Executive Director's Recommendation

Commission Meeting: February 7, 2019

PROJECT National World War I Memorial Pershing Park Pennsylvania Avenue between 14th and 15th Streets, NW Washington, DC	NCPC FILE NUMBER 7682
SUBMITTED BY United States Department of the Interior National Park Service	NCPC MAP FILE NUMBER 1.23(73.10)44854
REVIEW AUTHORITY Commemorative Works per 40 U.S.C. § 8905 and Public Law 113-291	APPLICANT'S REQUEST Approve preliminary site development plans
	PROPOSED ACTION Approve preliminary site development plans with comments
	ACTION ITEM TYPE Staff Presentation

Memorial Wall as endorsed by CFA

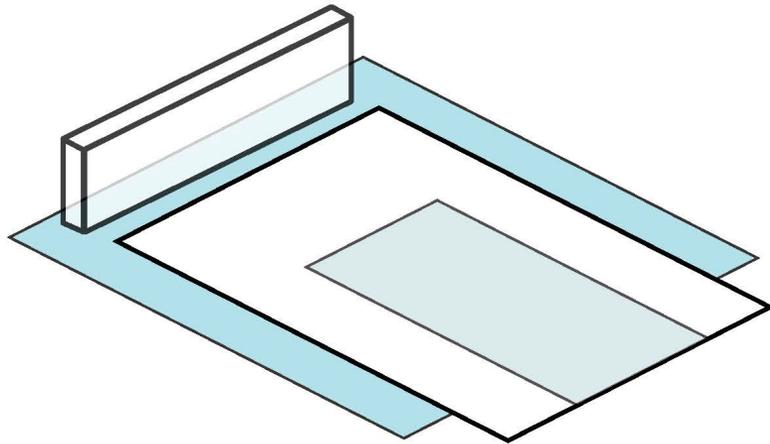
Finds the proposed treatment of the western face of the memorial wall has improved to include a monolithic granite finish and water feature reminiscent of the original Pershing Park fountain, while a quotation regarding the search for peace will provide a counterpoint to the wartime imagery and narrative found on the eastern face of the wall.

The western face of the wall has also been updated to include a monolithic granite finish that is reminiscent of the existing site fountain. A continuous flow of water over the wall will provide sound and movement, while a quote will be provided on the wall that will reference a narrative related to the search for peace. Planters in the terrace facing the wall have also been adjusted to allow the space to function for gather and contemplation. Overall, staff recommends the **Commission find the proposed treatment of the western face of the memorial wall has improved to include a monolithic granite finish and water feature reminiscent of the original Pershing Park fountain, while a quotation regarding the search for peace will provide a counterpoint to the wartime imagery and narrative found on the eastern face of the wall.**

And further, the **Commission finds the space created between the western terrace steps and wall can function as a contemplative space when the water feature is operating.**

PRIMARY COMMEMORATIVE ELEMENTS: DEVELOPMENT OF POOL AND WALKWAY LAYOUT STUDIES

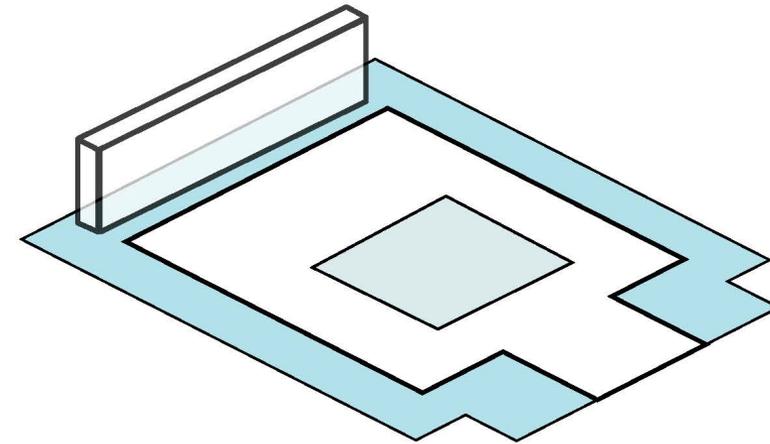
Notes the applicant has submitted two options for the pool and walkway configuration, including the “U”-shaped walkway, and the “Island” walkway.

Supports the “Island” walkway approach as it reinforces the edge of the original pool and appears as a deliberate and contemporary insertion into the historic park fabric.

After further review, the applicant has developed another pathway design that is preferred. This new “island” approach includes a central platform in the middle of the pool, with a single pedestrian connection to the plaza. The center of the platform includes a scrim of water that is shallow in depth, while the area around the platform retains deeper water, similar to the original pool design. This design allows the deeper water to encircle the platform and reinforce the footprint of the original pool. As such, staff recommends the **Commission support the “Island” walkway approach as it reinforces the edge of the original pool and appears as a deliberate and contemporary insertion into the historic park fabric.**

“U” Walkway and Scrim

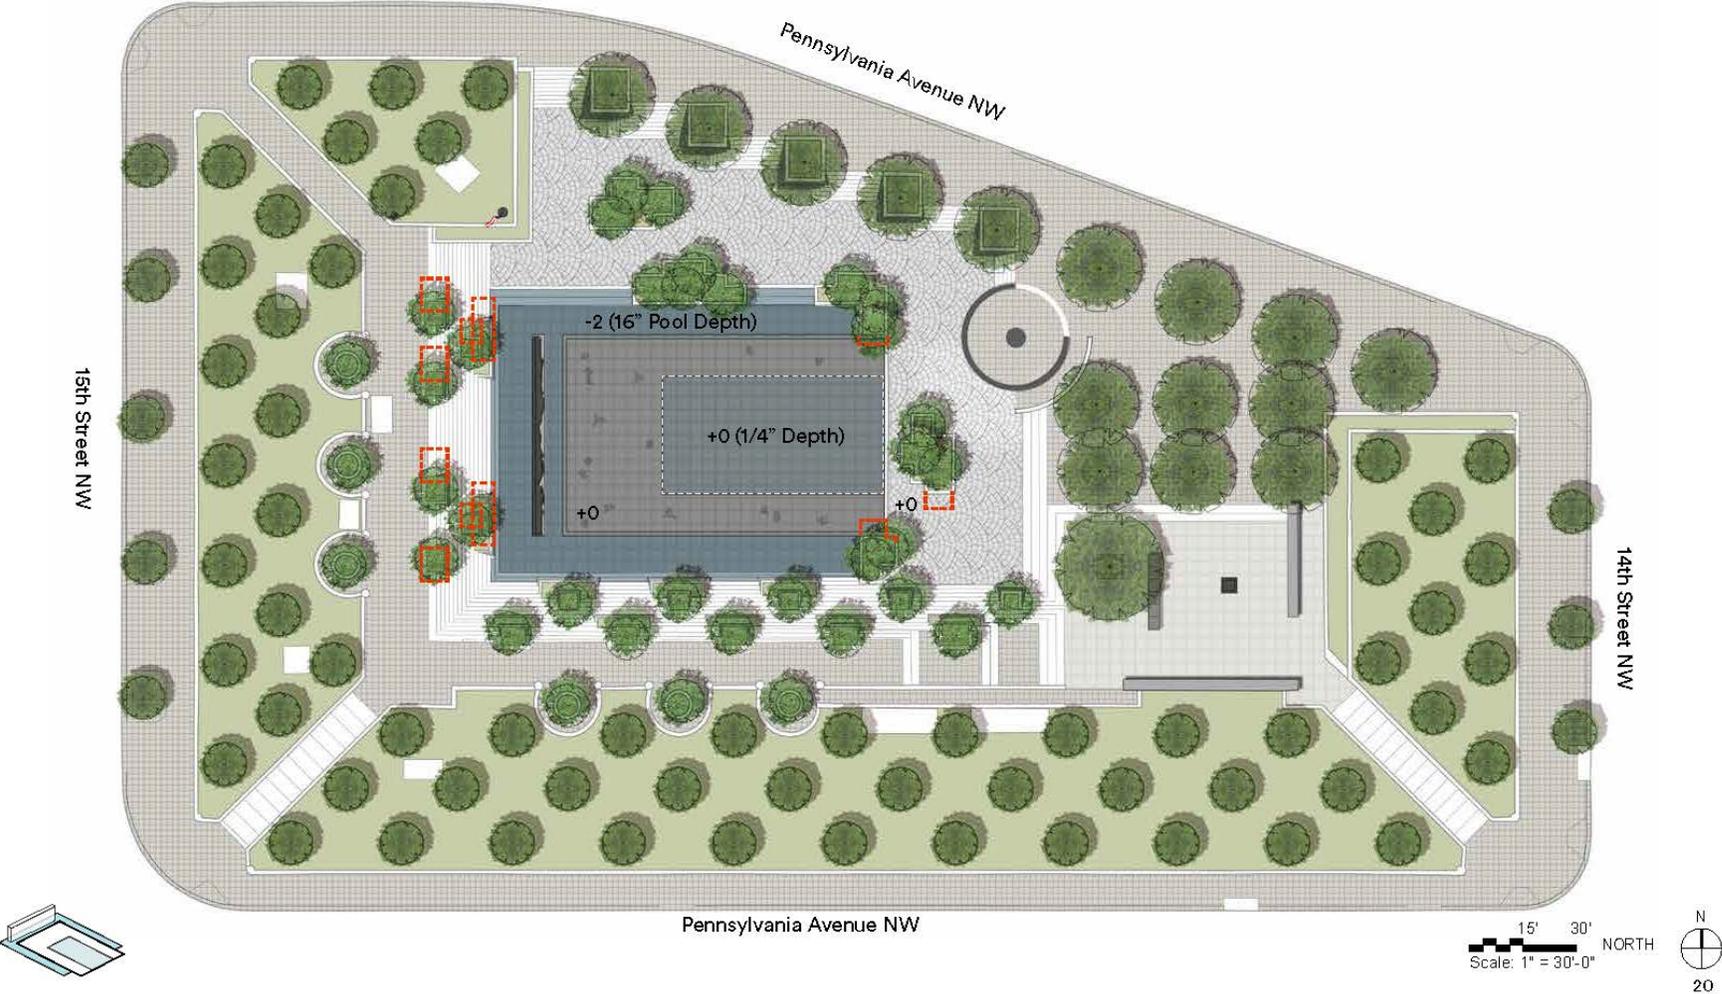
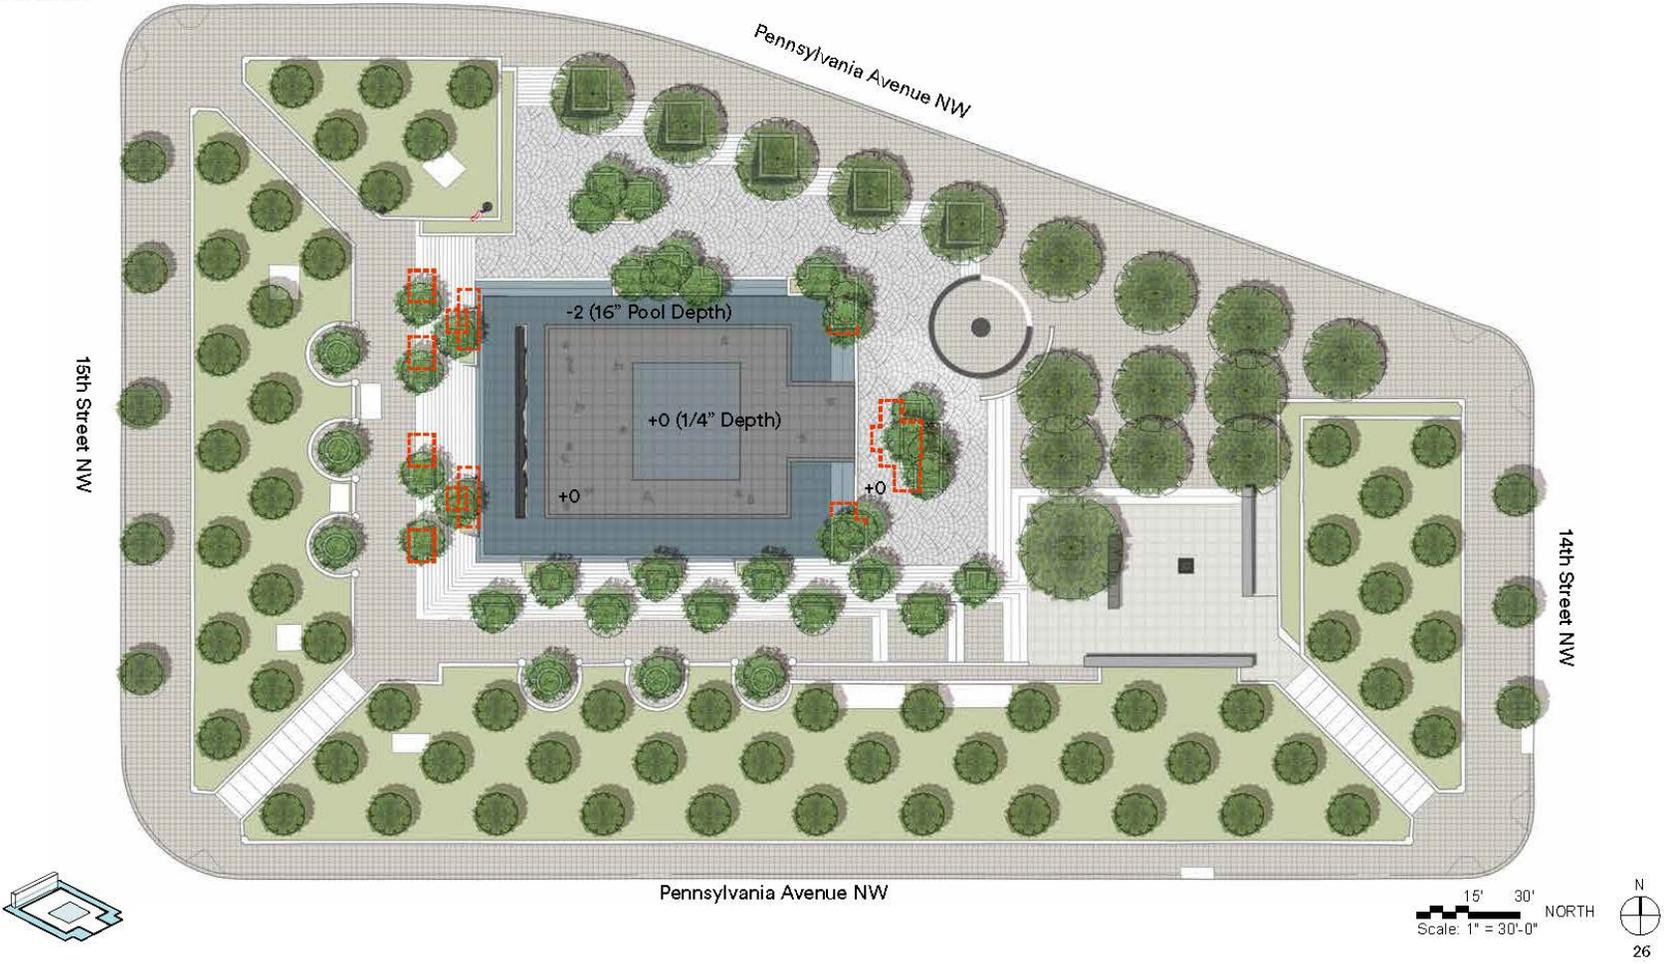
The Committee of 100 has advocated a simplified design in terms of the walkways and the pool and with better connecting the World War I Sculptural Wall to the surrounding park. However, the World War Centennial Memorial Commission, and its design team, has advocated designs in which the area for viewing the World War I Memorial Sculpture Wall is isolated from the surrounding urban park area. First there was the “L Shaped Walkway” and then the “U Shaped Walkway”. The latest design has two alternatives arrangements of pool, scrim and walkways. The first is the “U Shaped Walkway” and the second is the “Island Walkway” in which visitors to the Memorial Wall enter the area for viewing the Memorial Wall by a walkway from the east. The large “Island” is therefore cut off from the south and north sides of the overall park.

Modification to the “U Shaped Walkway” Design

As indicated in our October 1, 2018 letter to NCPC, the Committee of 100 suggests shifting the southern walkway south so that it adjoins the sloping steps to the south. This would mean the pool would not be broken up by a walkway. This change would provide a direct walk from the Pershing Statue area to the World War I Memorial Wall and could also provide for a stair walkway to the upper level on the west side of the park.

The north side of the “U Shaped Walkway” could also be shifted north. These changes would make the pool more meaningful and be closer to the original design of the pool in Pershing Park. We believe these changes would also simplify visitor access to the WWI Memorial Sculptural Wall. The Committee of 100 believes this modified design would be the best solution for the WWI Memorial in Pershing Park.

SOUTHERN AND EASTERN ACCESS: PROPOSED

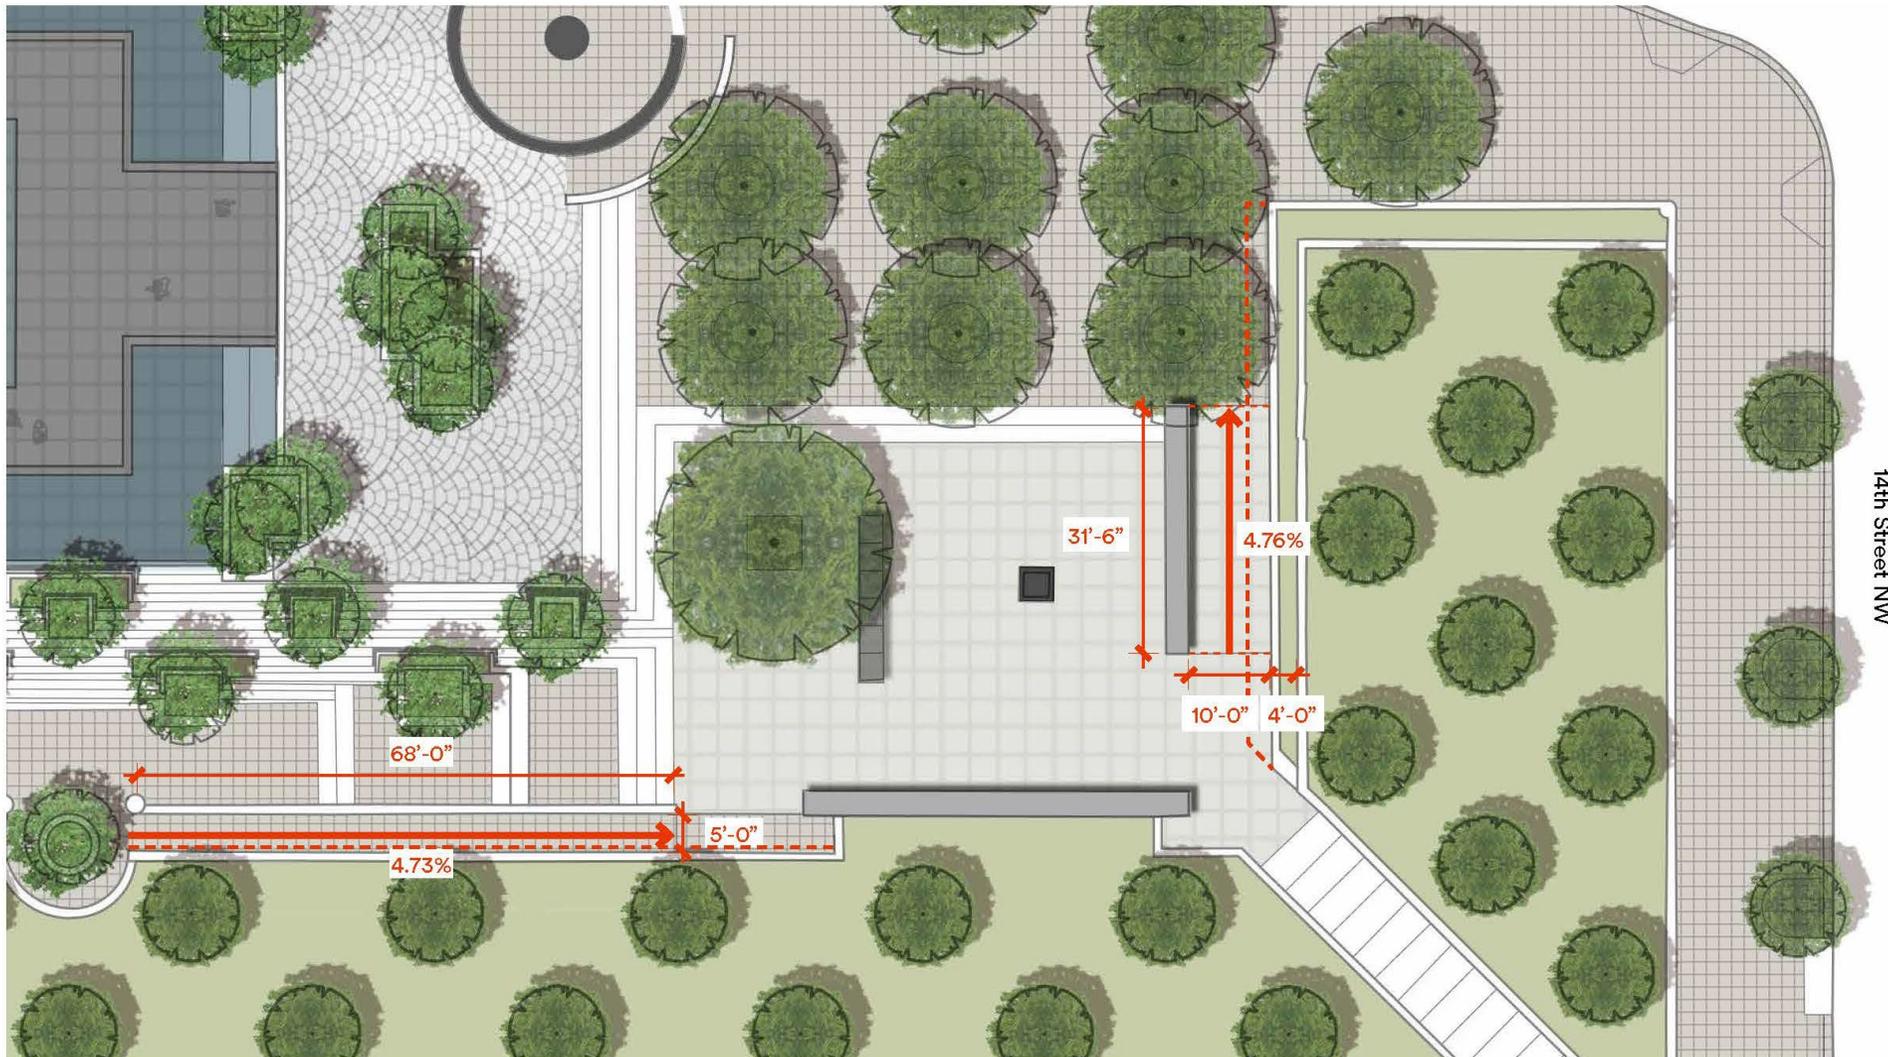
In its review, the Commission also endorsed the interventions proposed on the east and south sides of the park to accommodate contemporary standards for barrier-free access.
